PLANNING COMMITTEE AGENDA - 28th February 2018

UPDATES

Local Highway Authority - 22 February 2018

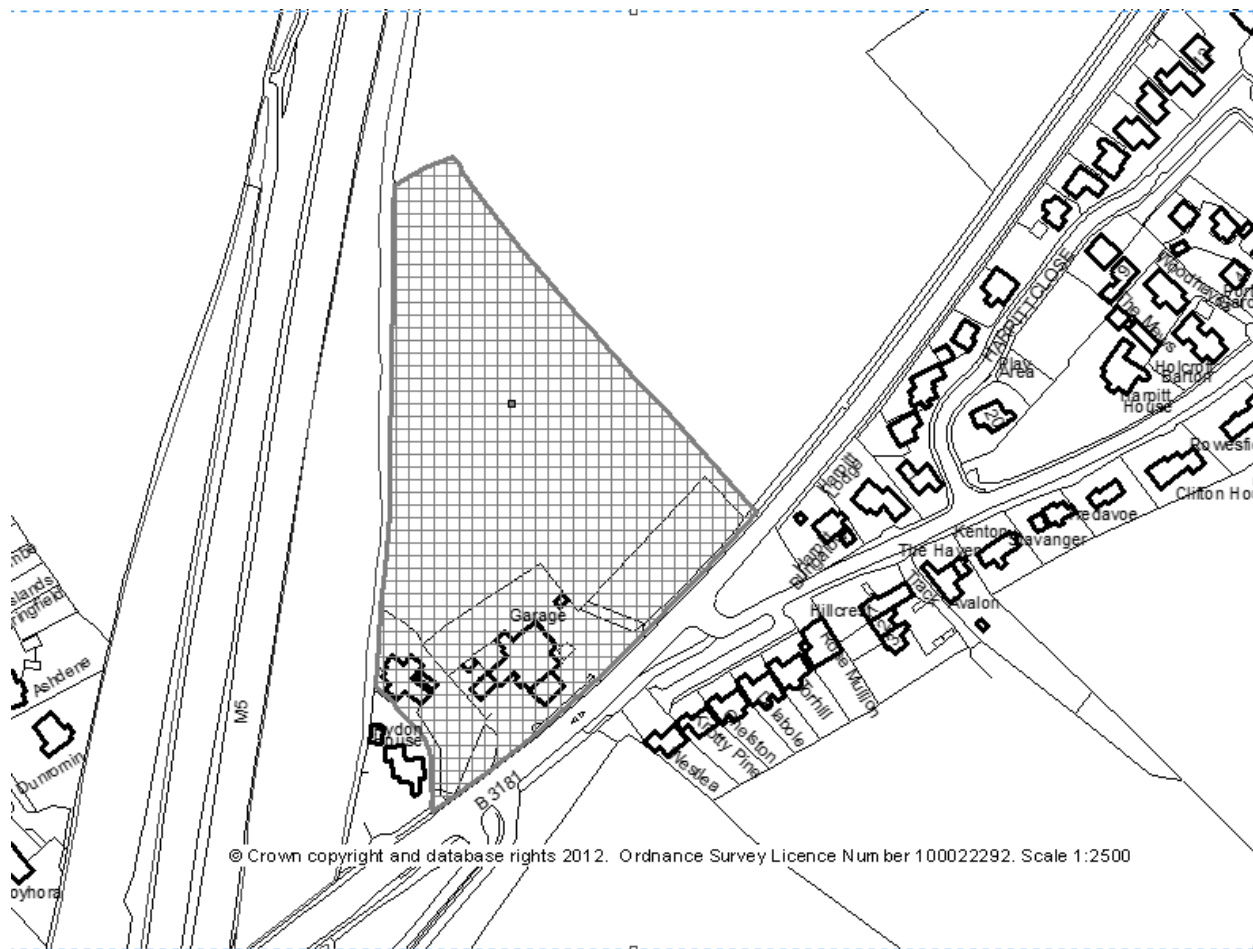
1. This is a cynical Trojan horse application by the landowner to obtain a new access in the hope of residential development on a steep hillside, outside the 30 mph limit.

2. Measurements are not given for the retaining wall or the grass verge where the hedgerow is to be removed. The plan does not appear to be accurate on highway adjoining boundaries which may have been tweaked to fit the proposal.

3. The highway 'road narrows' sign and 'double bend' sign will not be properly visible to motorists in the relocated position.
4. The engineering works associated with this proposal are inadequate given the very steep incline particularly in wet weather.

5. To turn from School Lane into the new entrance with a 16m long tractor and trailer, grain trailer, or anaerobic digester waste trailer, will mean a wide turning circle and driving onto the curtilage of the listed Lodge opposite to achieve the turn, crossing from one side of the lane to the other and needing high revs to get up the very steep gradient.

6. Given the size and weight of vehicles and narrow width of turn and very steep incline, there would increase the health and safety risks.
7. There are no pedestrian pavements along the very narrow School Lane making the risk to villagers and children even greater walking to school and The Bury.

8. The proposed drains are totally inadequate to deal with the rain water and storm water run off from the concrete pad - soil and mud will also be dragged onto the highway. In addition where does the storm water and soil go once it enters the chamber on the plan?

1. This is not for this application to consider and is speculation, however, the access being provided for agricultural use would not be suitable for a residential estate road and significant further works would be necessary along with suitable transport assessments for any housing generations will be necessary to determine suitability for the site for an increase in traffic.

2. Items 2, 3, 4 I have considered in the whole. The full width of verge and location of the realigned bank will be determined by the visibility splays. The current configuration with the retained bank was a desire from the Planning Authority to maintain the bank and general street scene. The Highway Authority are happy to accept this plan, albeit less than satisfactory, based on the need for the developer to enter into a licence with the Highway Authority where greater detail can be submitted in terms of technical aspects, but the layout, materials, visibility splay provision of drainage, radii and widths have been determined.

5. The swept path of agricultural vehicles entering the site from school lane from the north have been taken into consideration and that is why a 10m radii curve into the site and the lane /access width are as they have stipulated.

6. The gradient of the access has been stipulated as no greater than 1 in 10 for the new section which is the maximum gradient accepted by the Highway Authority and the hard surfacing of the access for the first 6.0m will cater for the skid resistance of the access.

7. The introduction of the drainage is a benefit over the existing access which is greater than 1 in 10 and has no restraint to water entering the highway. Details of the soakaway will be dealt with through the licence. The hard surface identified on the plan is the necessary requirement that allows a full wheel rotation and the reasonable removal of mud and stones before a vehicle enters the public highway. While greater detailed drawings would be desirable the plans submitted have sufficient annotation from a Highway Authority perspective to work with particularly given the need for a licence under the Highway Act.
